# UNITED STATES PATENT AND TRADEMARK OFFICE

APPLICATION NO.	FILING DATE	FIRST NAMED INVENTOR	ATTORNEY DOCKET NO.	CONFIRMATION NO.
10/816,780	04/02/2004	Timothy A.M. Chuter	12730/253	9975

## Office Action Summary

## DETAILED ACTION

5,667,523

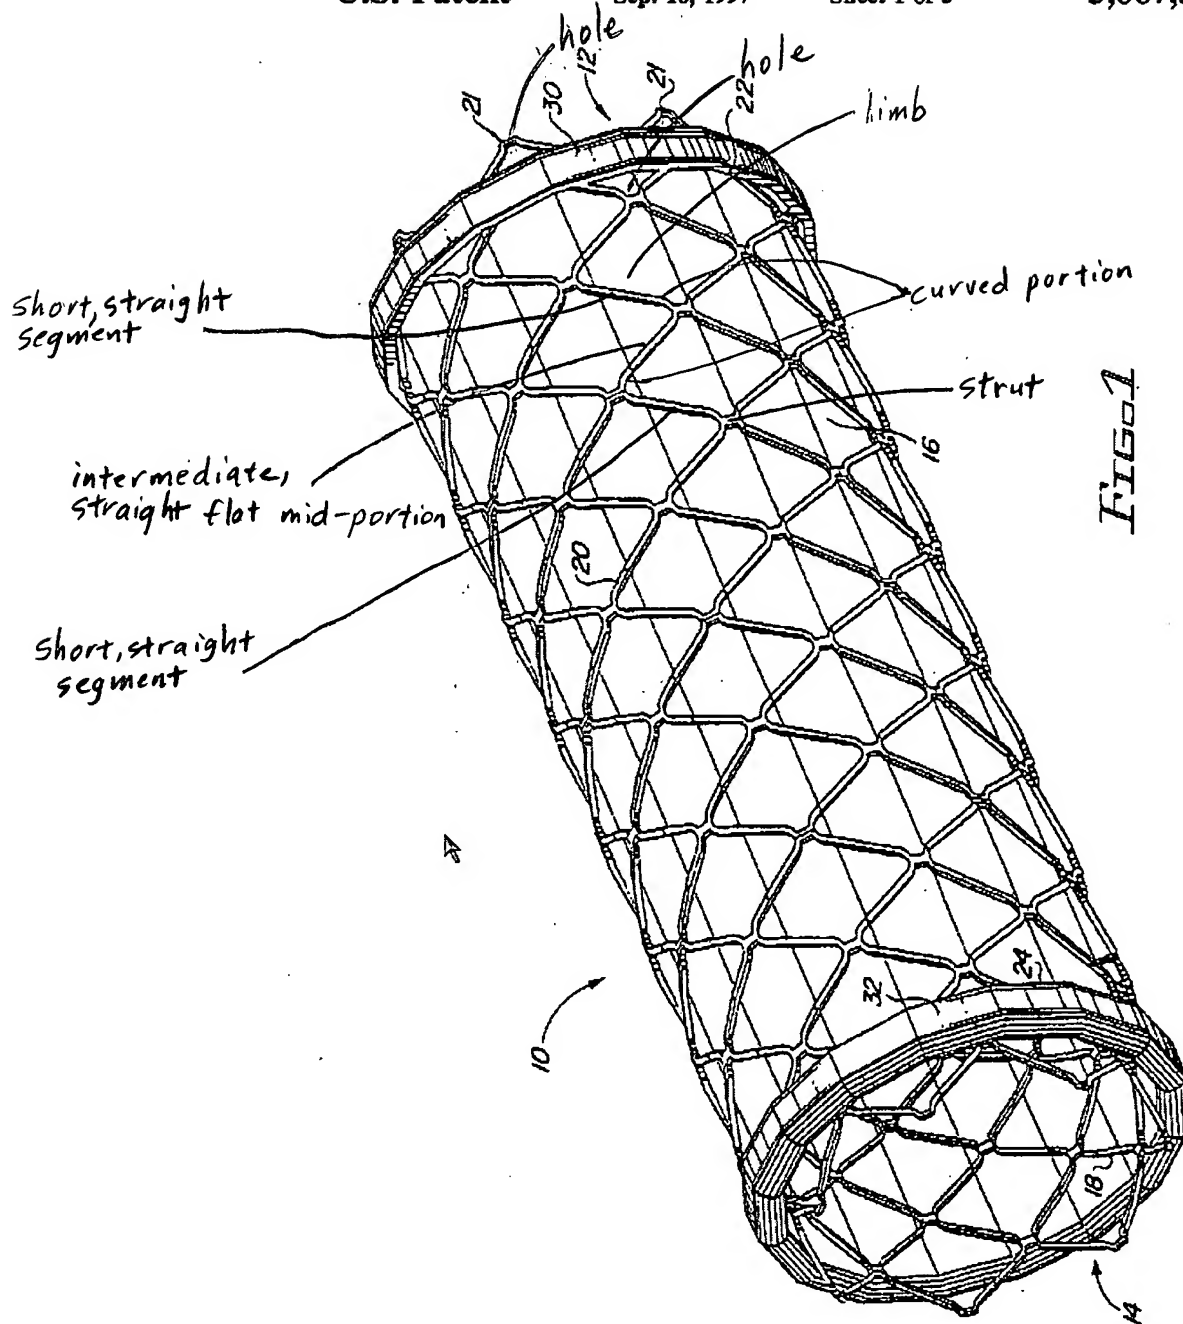
2. Claims 12-18, 24, and 25 are rejected under 35 U.S.C. 102(e) as being anticipated by Bynon et al. (5,667,523). Bynon et al. disclose, at least in figure 1, a limb or a stent comprising at least one limb having a cross sectional profile in which at least one segment is flat and straight, where each limb is comprised of two curved portions having opposite direction of curvature, an intermediate straight, flat mid-portion connecting the two curved portions, and short straight segment at each end; where the intermediate straight, flat mid portion is angled with respect to the short, straight segments at each end in an expanded state, where the stent has been provided with at least one strut in order to augment expansion, where the stent has been provided with a multiplicity of struts to supplement each of the limbs, where the stent comprises a multiplicity of identical limbs or wires in order form a cylindrical structure, where the overall length of the stent is a multiple of the overall diameter of the cylindrical structure, and where the end of at least one limb is provided with a hole (at 21 or a trapezoidal

slot). See the yellow-shaded regions in the figure below for an illustration of the abovementioned limitations.

**4,793,348**

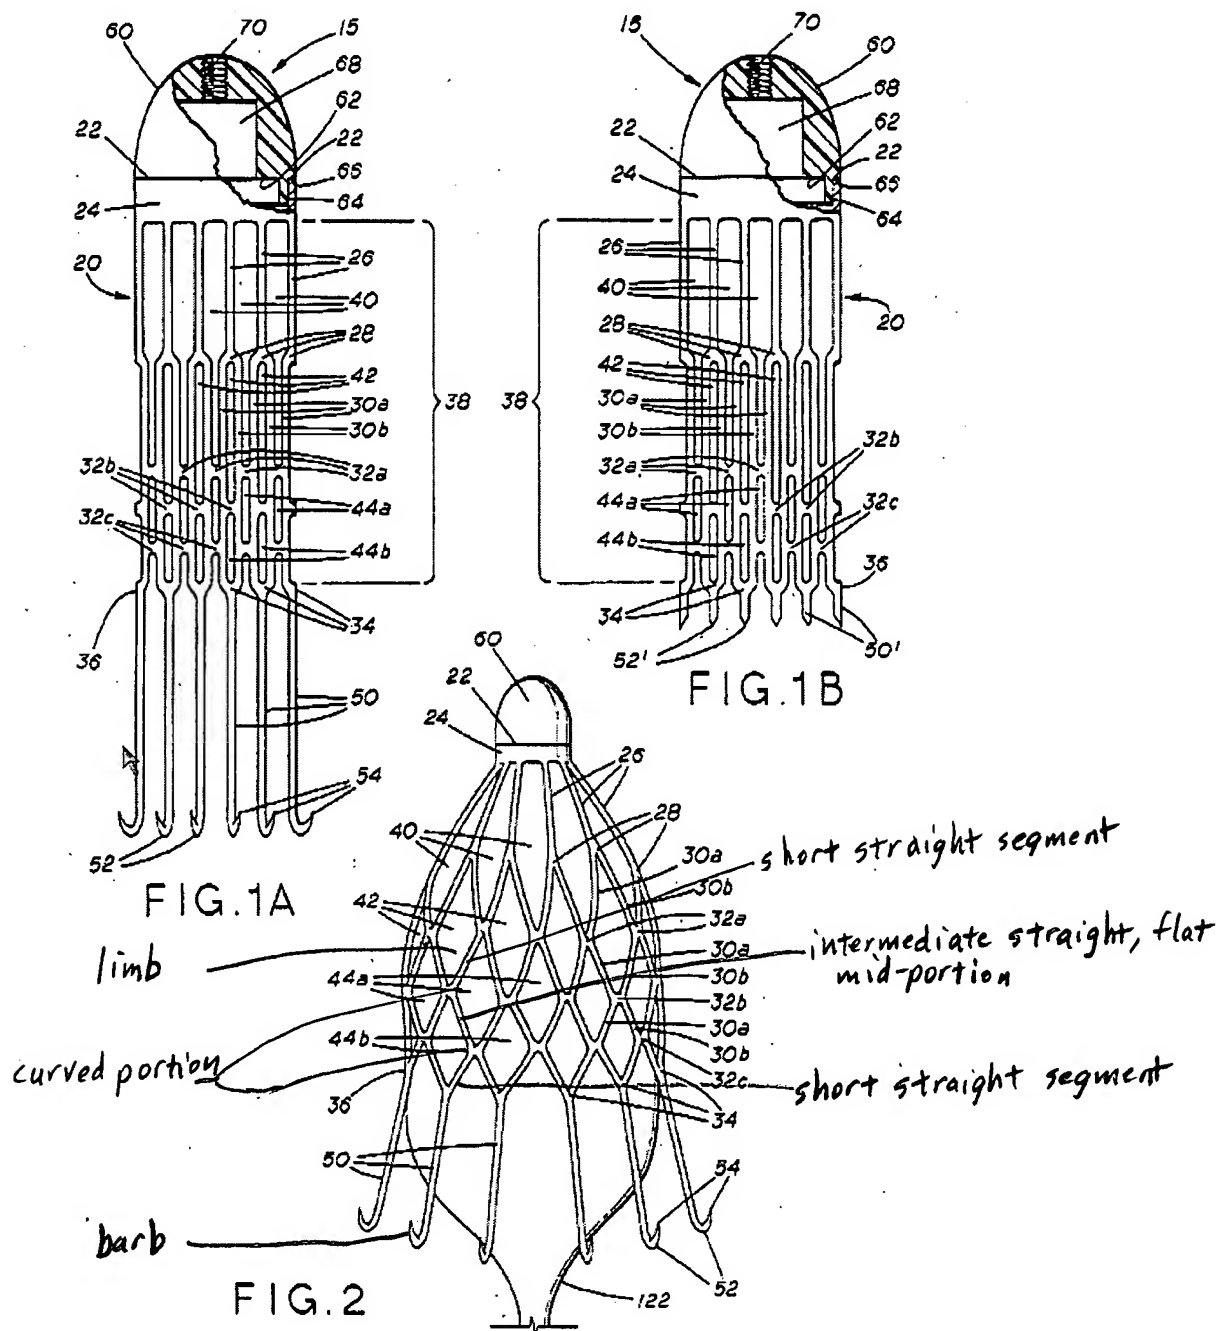
3. Claim 22 is rejected under 35 U.S.C. 102(b) as being anticipated by Palmaz (4,793,348). Palmaz discloses, at least in figure 2, a stent (20) comprising at least one limb having a cross-sectional profile in which one segment is flat and straight, where each limb is comprised of two curved portions having opposite directions of curvature, an intermediate straight, flat mid portion connecting the two curved portions, and short straight segments at each end, where the end of each limb has been provide with a barb (54). See the yellow-shaded region in the figure below for an illustration of the abovementioned limitations.
